CD. NO.	STATE	FED. AID	PROJECT NO.
3	COLO.	283 B	1

COLORADO STATE HIGHWAY DEPARTMENT

PLAN AND PROFILE OF PROPOSED FEDERAL AID PROJECT NO. 283B STATE HIGHWAY NO. 1 LARIMER COUNTY

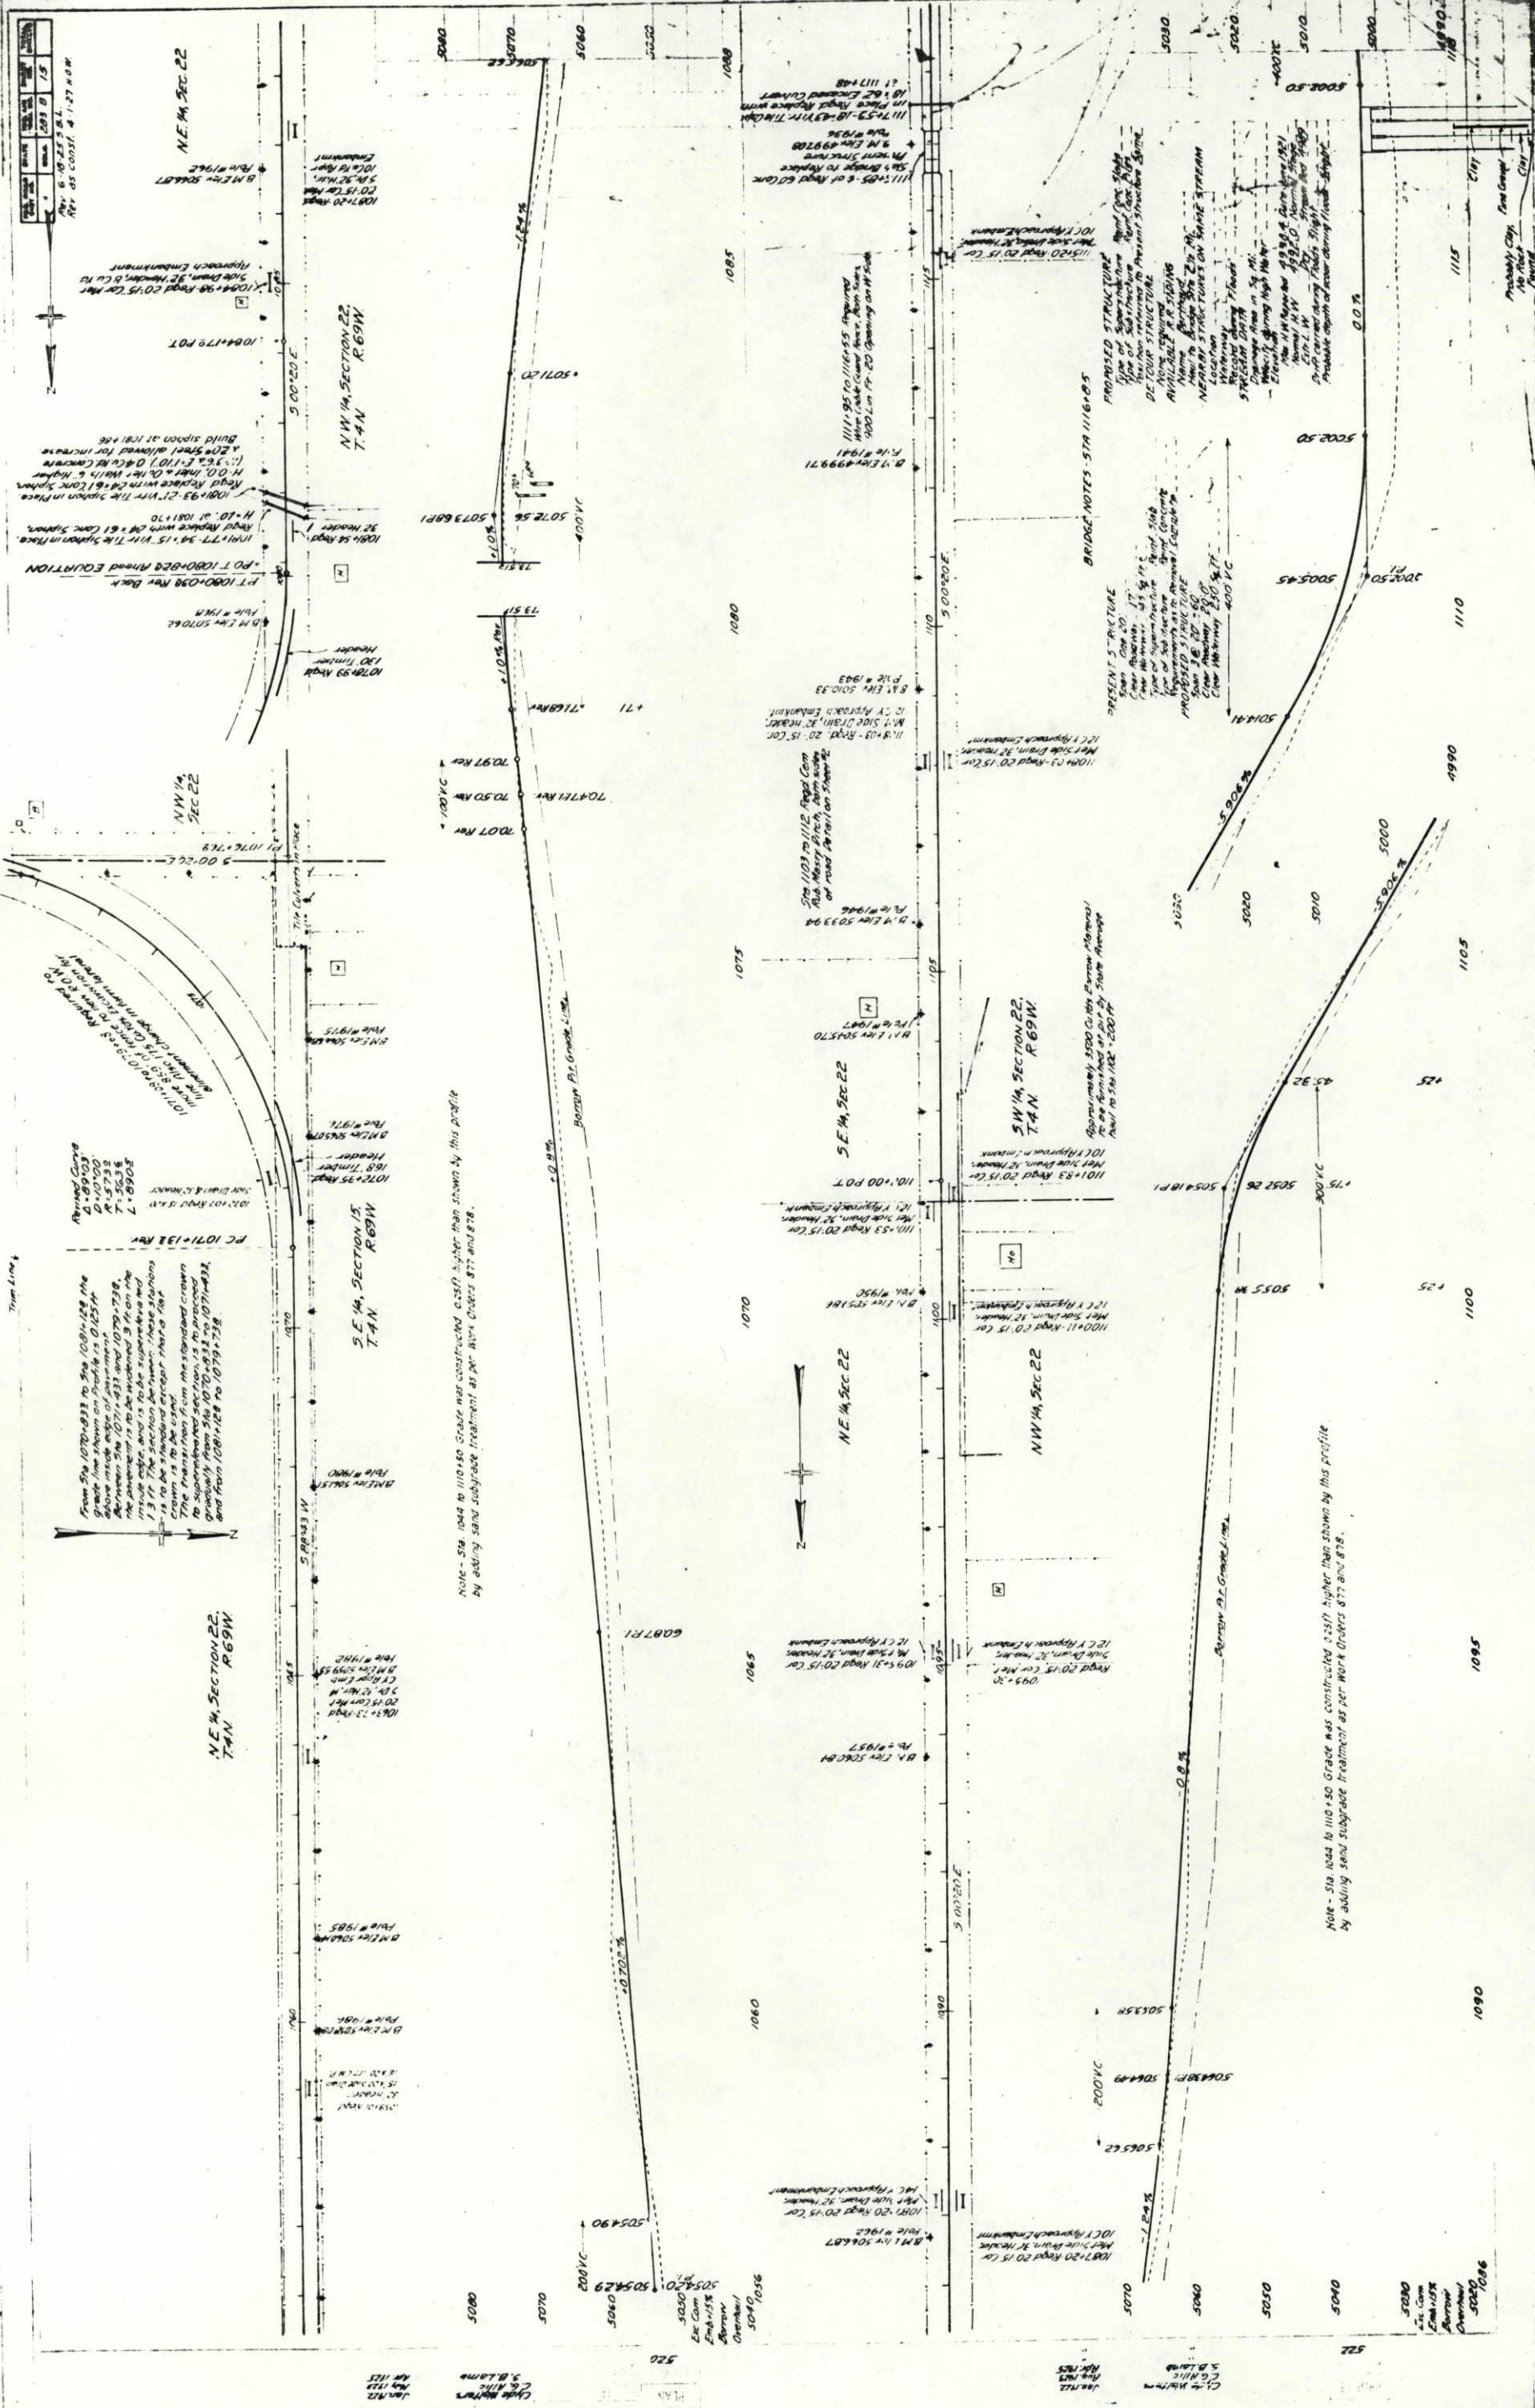
From Sta 1070+00 to Sta 1081+28 the grade line shown on profile is 0.125 ft above inside edge of pavement. This is to be corrected to 0.00 ft on the inside edge, and is to be supervised and 1.3 ft. The section between these stations is to be standard except that a 10'± transition from the standard crown to super-elevated section is to proceed gradually from Sta 1070+00 to 1071+43, and from 1081+28 to 1079+58.

Note - SW 1/4 1024 to 1110+50 Grade was constructed 225ft higher than shown by this profile by adding sand subgrade treatment as per Work Orders 877 and 878.
